CUSTOMER SERVICES
TELE-NEWS

FILE: Service and Parts No. 95

SUBJECT: Modifications and adjustments to improve starting and operating characteristics for (early model) Battery Charger's.

SERIES AFFECTED: Series 0.3TL-212R.

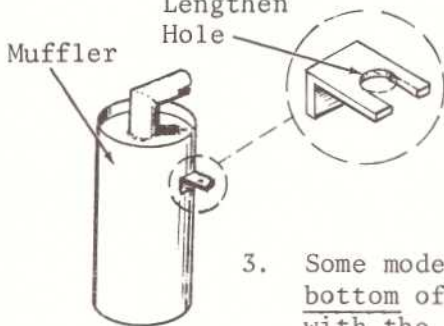
2. Metallic Knock(s). The normal starting and stopping torque reaction (turning motion) could cause metal to metal contact.

- a. The right rear corner of the generator adapter casting could strike the enclosure support bracket. To muffle this knock, temporarily pry the adapter casting away from the enclosure support bracket. Towards the right rear corner, install a 6 inch piece of self-adhesive weatherstripping (895-0152) between the metal surfaces. Allow the unit to then return to its normal position.

- b. The muffler can strike the lower air baffle plate when the muffler is not centered in the hole through the plate. To aid in the centering adjustment, change the round hole in the muffler mounting bracket to a lengthwise slot.
